STAFF REPORT AMENDED 6-12-80
CITY PLANNING COMMISSION

- APPLICATION:
1. Negative Declaration
 2. Amendment of 1965 Lindale-Florin Community Plan for 2+ vacant acres from Shopping-Commercial to Light Density Residential
 3. Rezone 6+ vacant acres from General Commercial, C-2 and Single Family R-1 to Townhouse R-1A
 4. Special Permit to allow 62 condominium units
 5. Tentative Map (P-9004)

LOCATION: Southeast corner of Stockton Boulevard and 48th Avenue

PROPOSAL: The applicant is requesting the necessary entitlements to subdivide an 8+ vacant parcel into one commercial parcel and one parcel to be developed with a 62 unit condominium project to be known as Stonewood.

TENTATIVE MAP
STONEWOOD
 CITY OF SACRAMENTO, CALIF.
 March 1980

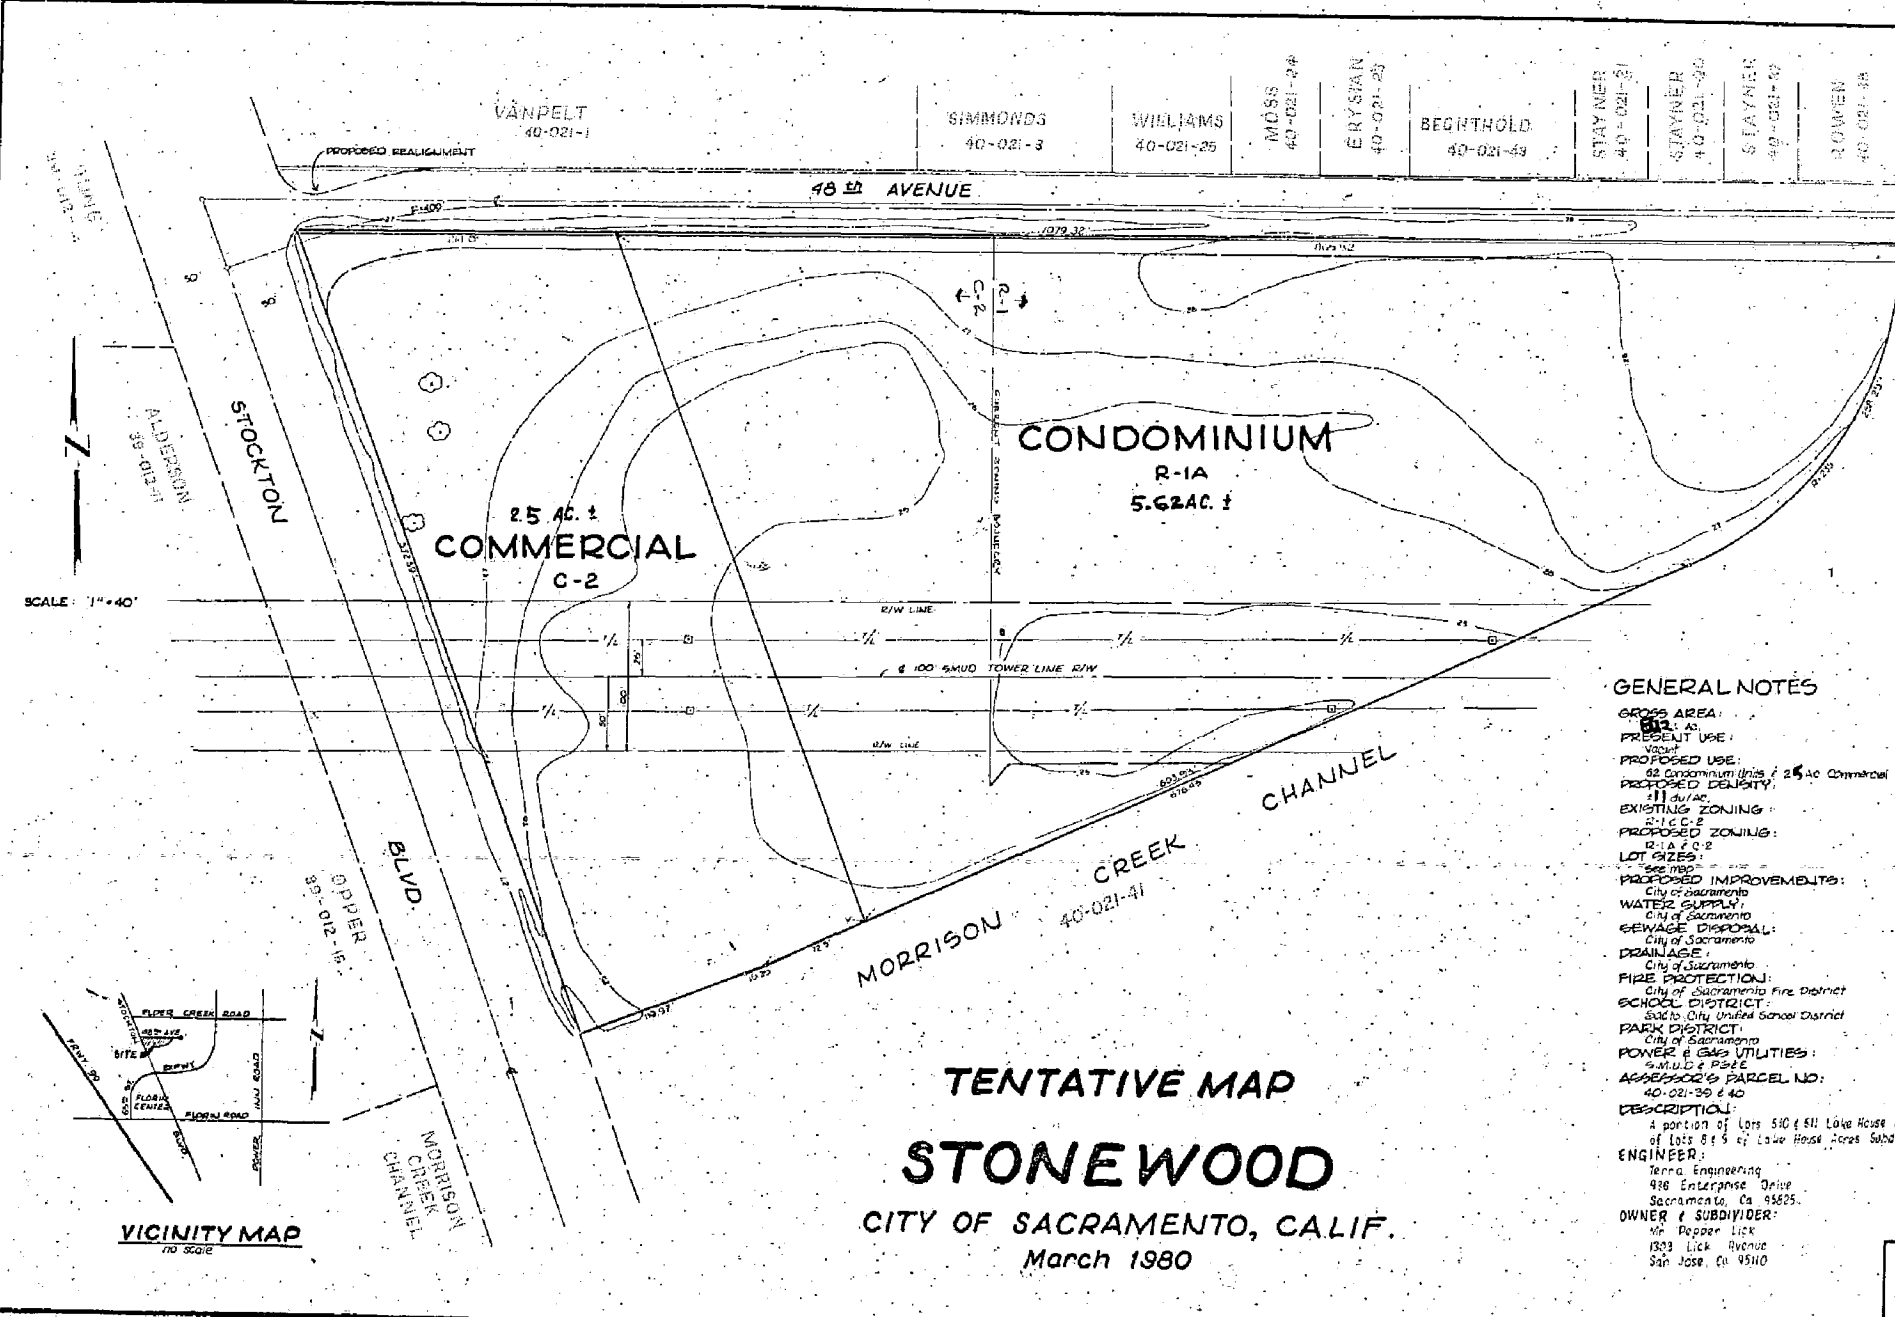
3. Staff notes that the site plan indicates a variable setback ranging from 15 feet to 27 feet along 48th Avenue. The site plan also provides for a minimum 10-foot setback from all the other property lines. Staff requests that the setback along 48th Avenue be intensely landscaped and bermed to a height of four feet, measured from the sidewalk or building pad, whichever is higher. Staff also requests that the applicant provide for a solid six-foot high masonry wall adjacent to the commercially zoned parcel.

5. The applicant's proposal indicates a central recreational area located primarily under the 100-foot powerline easement. Condominium projects usually include more in the way of amenities than just common open space. Such amenities include pools, spas, recreational rooms and tennis courts. In keeping with the concept of a planned development, staff suggests that a swimming pool be provided.
6. The site plan does not show the location of pedestrian paths. Staff is concerned with the units that face 48th Avenue. The orientation of these units encourages the use of on-street parking. Staff suggests that pedestrian walkways and berming be designed to encourage the use of off-street parking spaces.

- e. Applicant shall dedicate 27-foot half section along 48th Avenue and round corner;
 - f. Applicant shall dedicate cul-de-sac bulb (south side) on 48th Avenue;

- g. ~~The applicant shall provide for a six-foot high masonry wall along the western property line. The design of this wall shall be subject to the review and approval of the Planning Director (see condition e. - Special Permit Conditions)~~

- a. The applicant shall submit a detailed landscape and irrigation plan for the review and approval of the Planning Director prior to the issuance of building permits. These plans shall include the design elements as discussed in Item 4 of Staff Evaluation.
- b. The applicant shall submit a revised site plan which includes a common swimming pool for the use of the homeowners. This pool shall be constructed and in operation prior to the issuance of occupancy permits;
- c. The applicant shall use wood shingles or shakes for the roofing material of the units and utilize a mixture of wood and stucco for the side elevations, as illustrated by the elevations.

- d. Pedestrian walkways shall be shown on the final building plans. The units that are facing 48th Avenue shall include walkways that encourage the use of off-street parking.

TYP. SIDE ELEVATION
SCALE 1/8" = 1'-0"

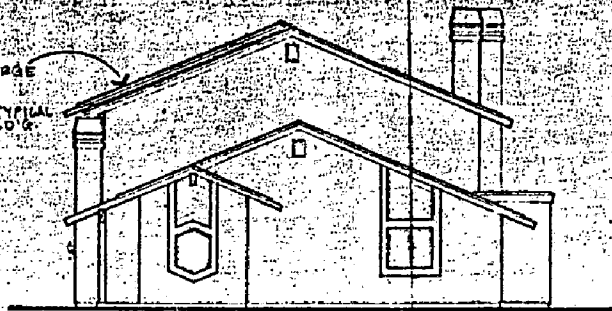
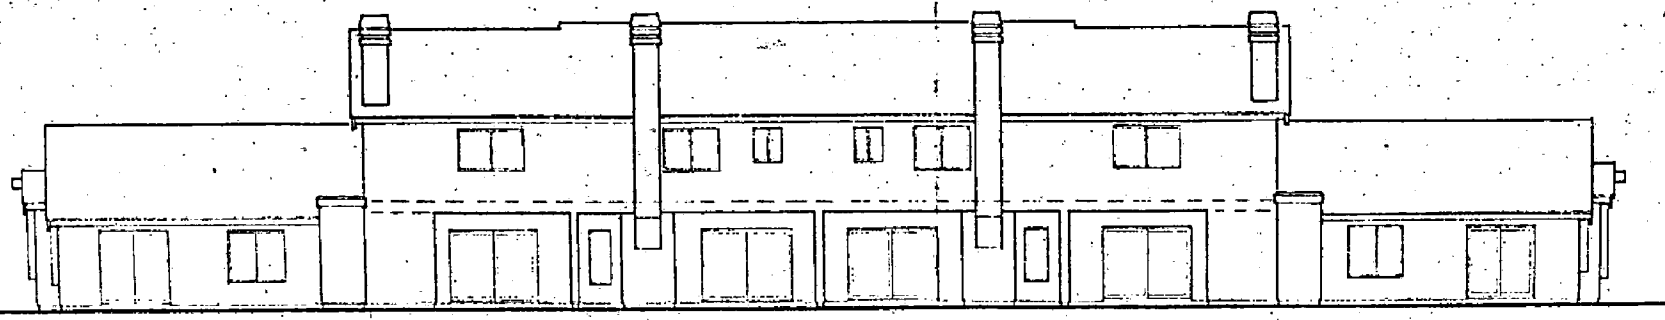
2. The applicant's plans indicate a mixture of one and two-story units clustered in groups of three to six units. Staff also notes that detached garages are provided throughout the site. The exterior building materials will be a mixture of roof sown plywood and stucco. In addition, the applicant indicates wood shakes will be utilized. Staff does not have any objection with the proposed structure.
